RE: 695 Bicknell Road

I reviewed the drawings and evaluated the neighborhood context. My comments and recommendations on the design are as follows:

ISSUES AND CONCERNS

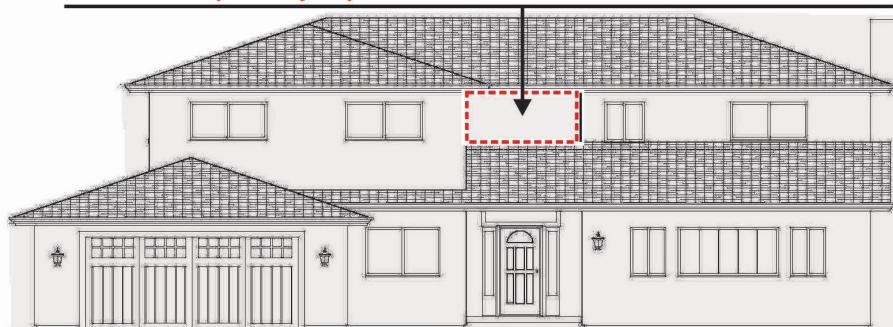
The project includes a second floor addition to the existing second floor plan, an infill addition to the rear of the first floor and the addition of a balcony extending across the full rear facade. - see illustrations below.

The proposed additions are modest and in keeping with the building form traditional to the architectural style. There are, however, a few issues related to the town's Residential Design Guidelines.

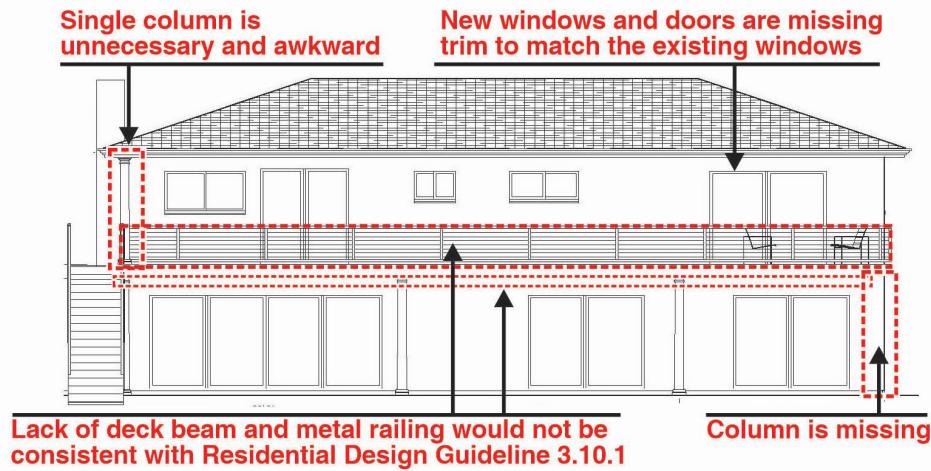
1. There is something missing and not coordinated at the second floor addition over the home entry. The floor plans call for an open space to the floor below but does not show an exterior wall.

**Unclear what happens in this area
Second floor plan says open to below but there is no outside wall shown**

1. Clarify the second floor plan above the home entry. I am assuming that the front wall of Bedroom 5 will continue in line with the front facade.
2. Add surrounding trim on all windows and doors consistent with Residential Design Guideline 3.7.4.

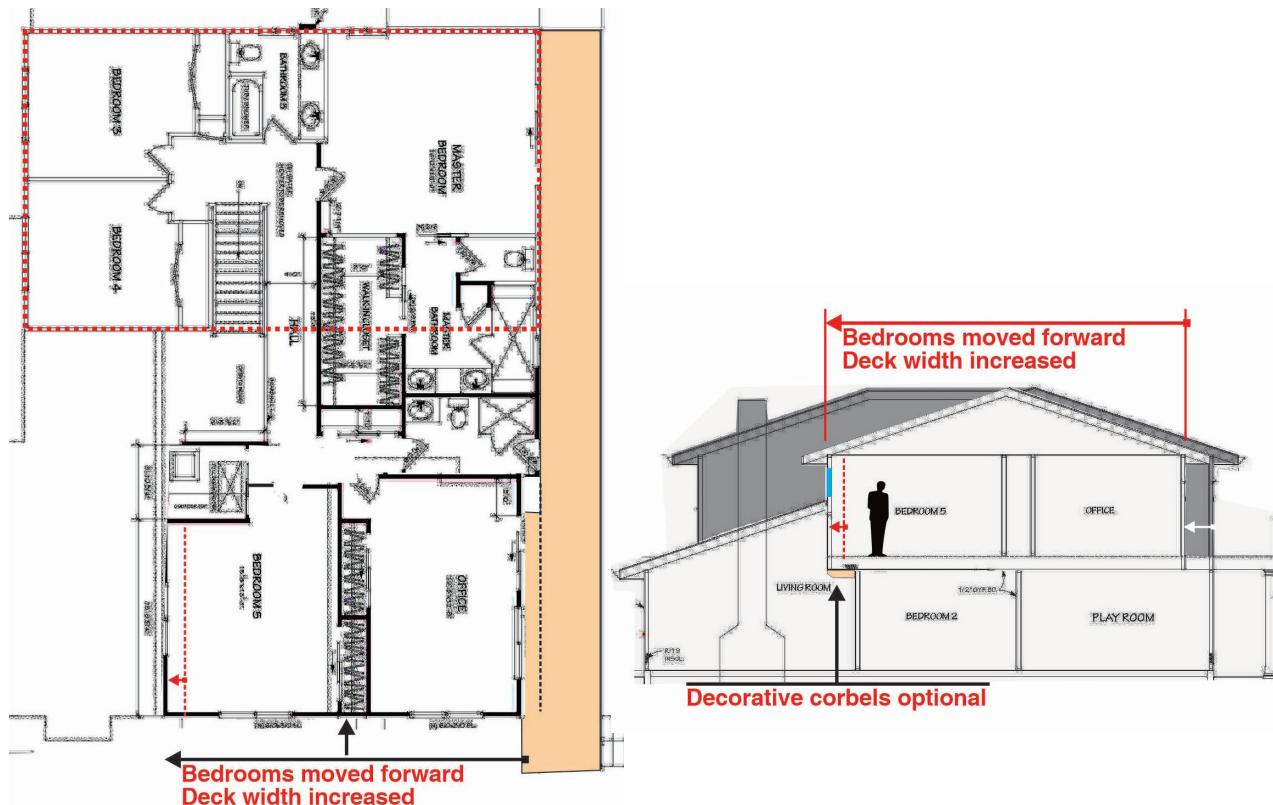
6. There is one other substantial concern that has some visual design issues but may be more of an issue of the applicant's construction detailing. The current proposal has an awkward front first floor roof form caused by the desire to have front-facing windows on the Bedroom 5 facade that match the existing second floor windows on Bedrooms 3 and 4. This would have some impact on the roof form view from the street but might not be critical. This roof form could be a potential construction roof drainage and waterproofing issue for the owner since it directs roof drainage into the adjacent wall rather than away from it which is usually the preferred solution.

6. The issue of the awkward second floor roof form and waterproofing is one that I believe that the applicant should address. If they wish to leave it as proposed, I do not believe that the resulting condition would be detrimental enough to recommend changes. However, should the applicant wish to explore alternatives to maintain the second floor use areas while improving the construction drainage and waterproofing details, a couple of approaches are illustrated below.

APPROACH B

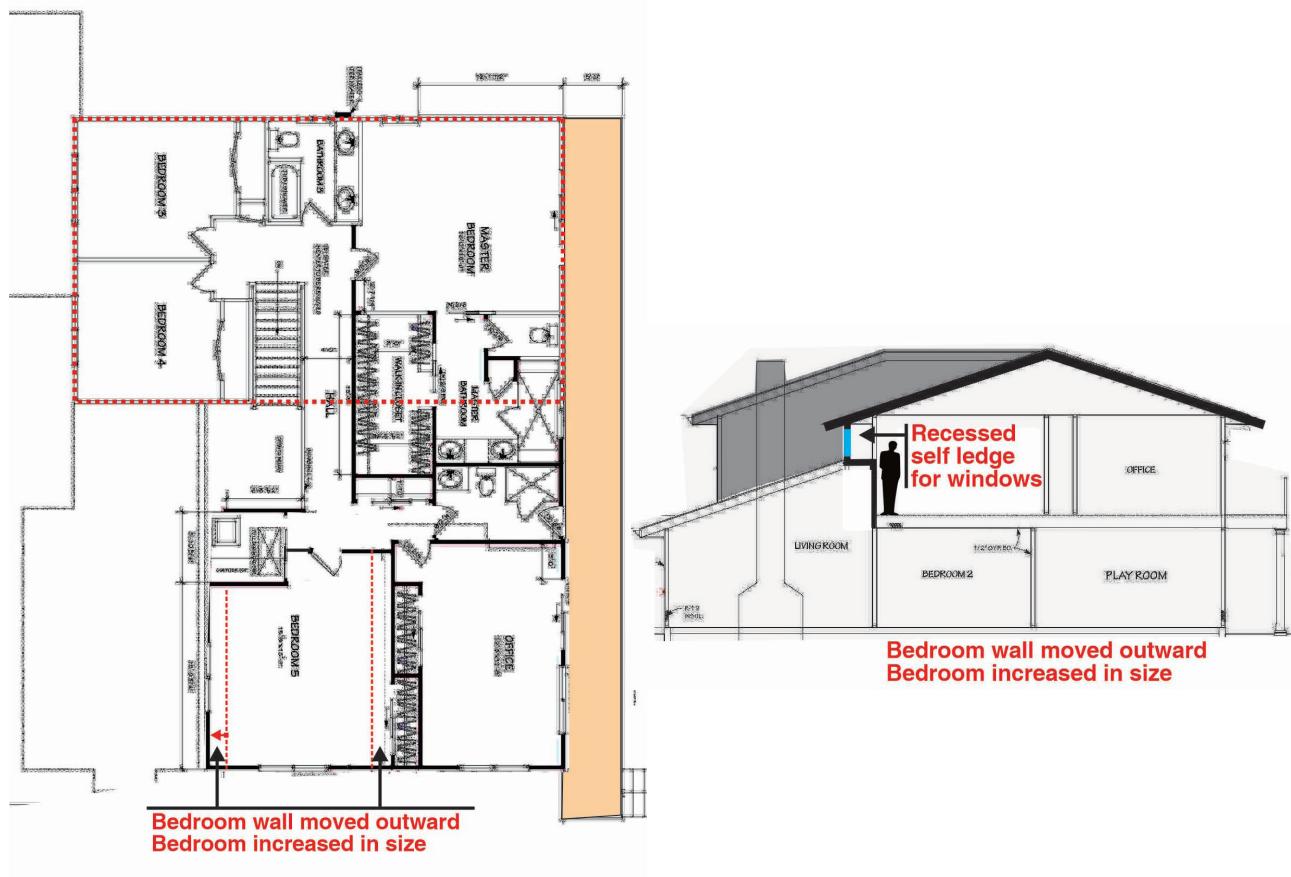
The simplest approach would be to shift Bedroom 5 and the office a bit toward the home frontage so that the first floor roof peak would hit the wall plane, eliminating the roof drainage toward the building face and maintaining the proposed windows. This is shown in the plan and section illustrations below. An option would be to retain the rear wall at the office in alignment with the adjacent rear wall by increasing either the depth of Bedroom 5 or the office.

The downside of this approach as shown is that a portion of the second floor Bedroom 5 volume would intrude into the first floor elevated ceiling space.

A similar approach that would leave the first floor Living Room volume untouched looks awkward in section but would be a simple fix. It would align the Bedroom 5 wall with the Living Room wall below and add an extended window ledge to bring a wall facade out to match the first floor roof ridge.
